# MANDATORY SERVICE BULLETIN

## NO. MSB-D4-056

Type: DA 40 D

Coolant Tank Cap – Pressure Relieve Test

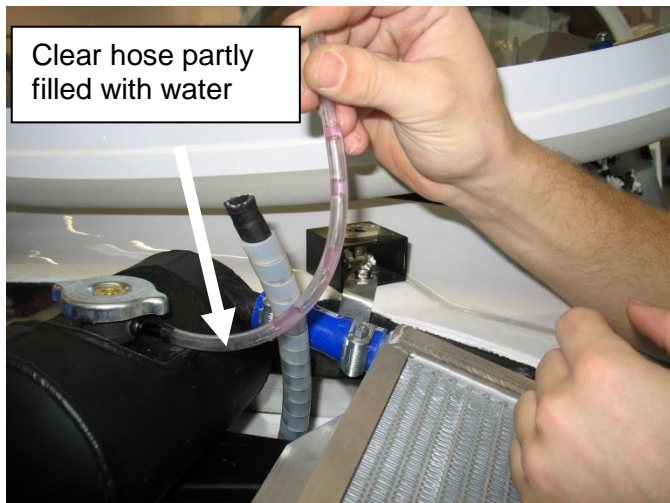
3. Unplug the breather line and install a clear hose. Fill clear hose partly with coolant liquid or water.

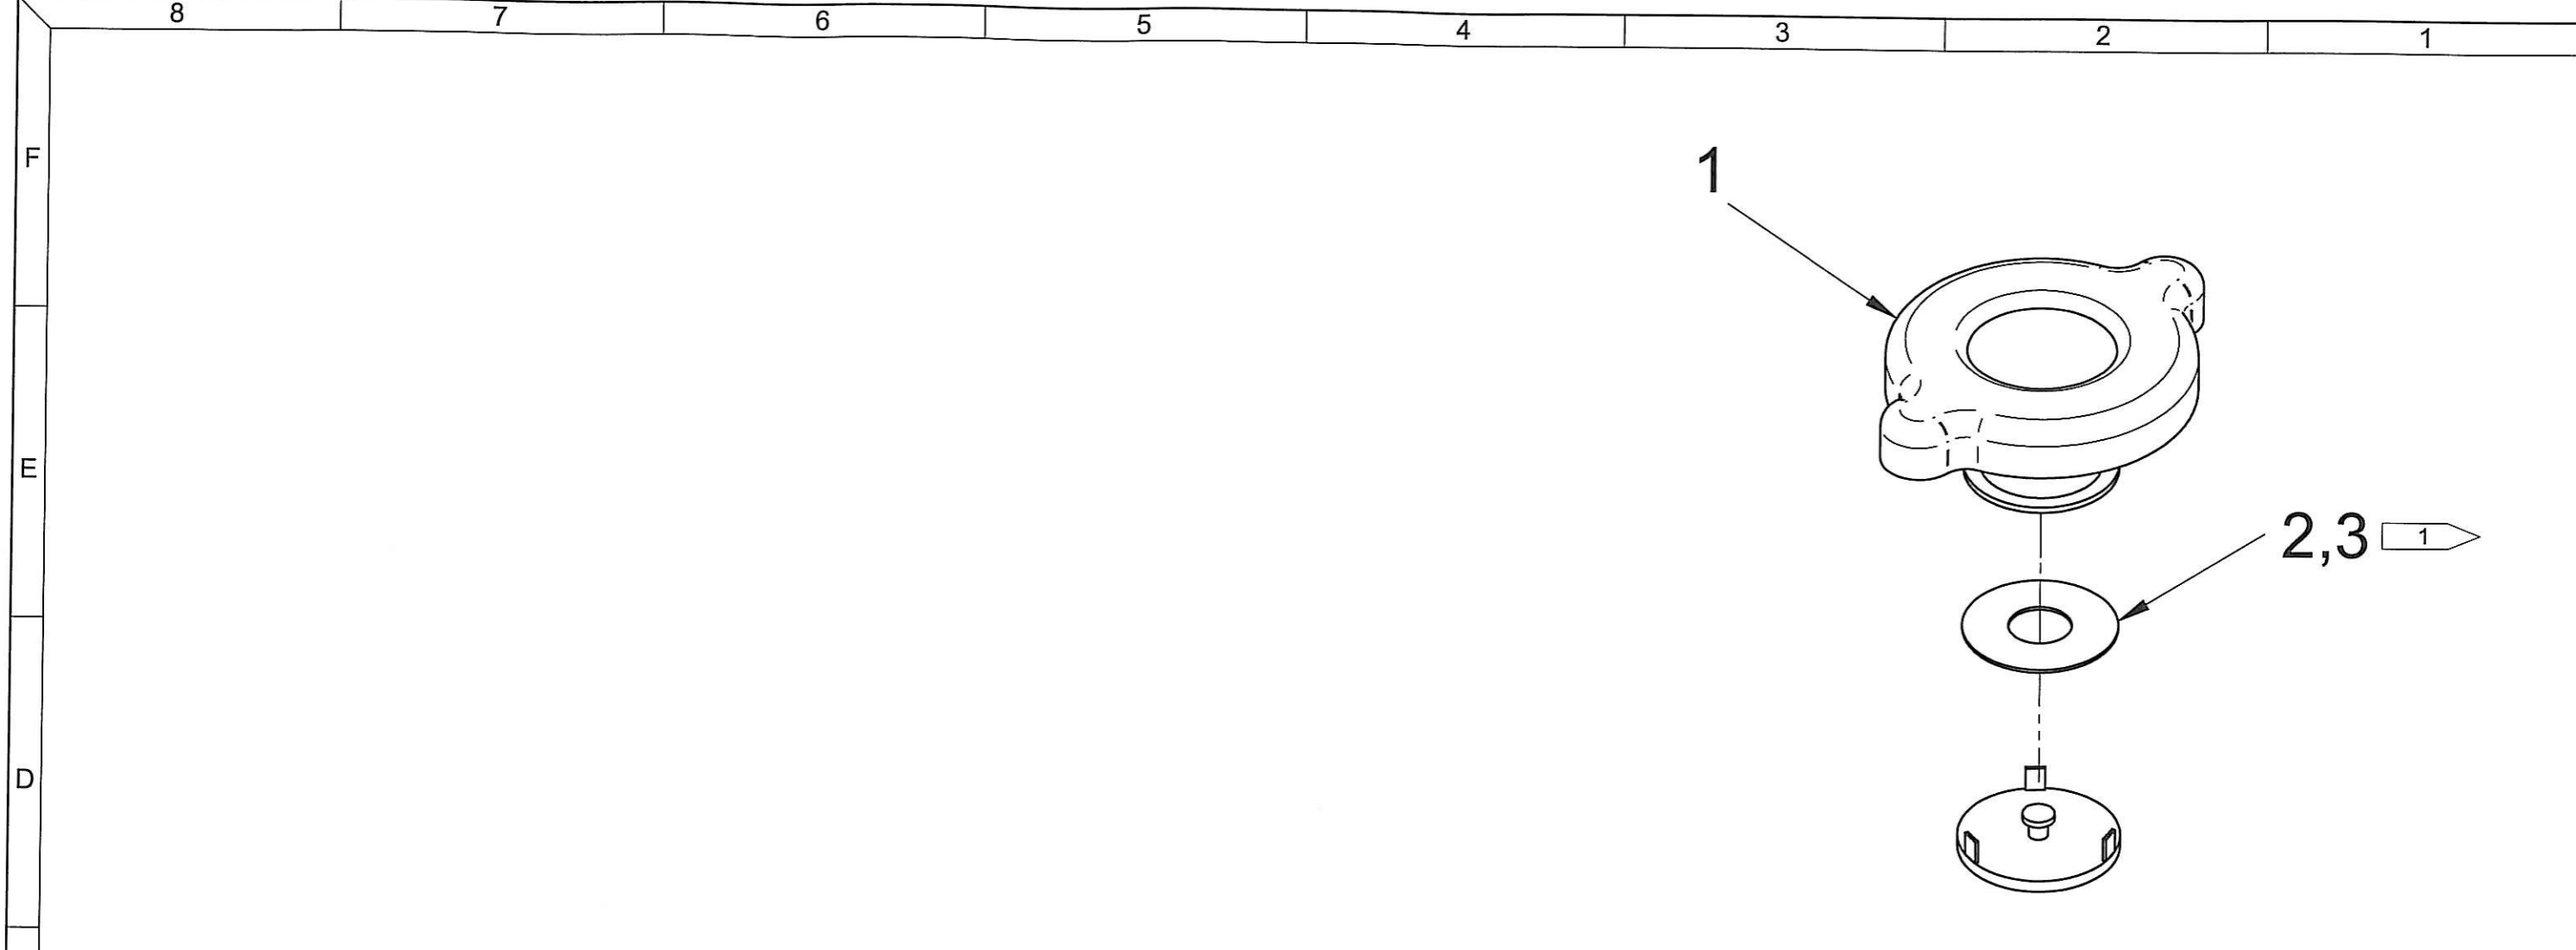
4. Put on the coolant tank cap and pressurize up to release pressure of the cap. Rising bubbles in the clear hose indicate pressure relieve.

**CAUTION** Check for a proper fit of the coolant tank cap.  
**CAUTION** The pressure must not exceed 2.3 bar (33.3 psi) at any time of testing.

6.	<p>For <b>both orientations</b> of the cap, the cap's relieve pressure must be within following limits:</p> <p>Minimum relieve pressure: <b>1,8 bar (26.1 psi)</b>          Maximum relieve pressure: <b>2,3 bar (33.3 psi)</b></p> <p><b>CAUTION</b> The pressure must not exceed 2,3 bar (33.3 psi) at any time of testing.</p>

7.	<p>If the caps relieve pressure does not meet the requirements the cap needs to be modified in accordance with drawing D60-7526-30-29.</p> <p>Redo the test procedure (items 4 and 5); add 1 washer each time until the requirements are met for both cap positions.</p> <p><b>NOTE</b> Before doing the pressure testing check the modified cap for proper fit. The sealing plane of the cap must be even and parallel to the tank's sealing plane.</p> <p><b>NOTE</b> It is just necessary to bend one of the 3 latches to remove the lower portion of the cap.</p> <p><b>NOTE:</b> Experience has shown that each latch can be bended (up and back again) 3 to 4 times. It is advised to alter the latches during the adjustment process.</p> <p><b>CAUTION</b> The bent latches must be inspected for cracks and proper fit before the cap gets released to service.</p> <p><b>NOTE</b> If the required relieve pressure is not achievable with by modifying the cap a new cap must be used.</p>
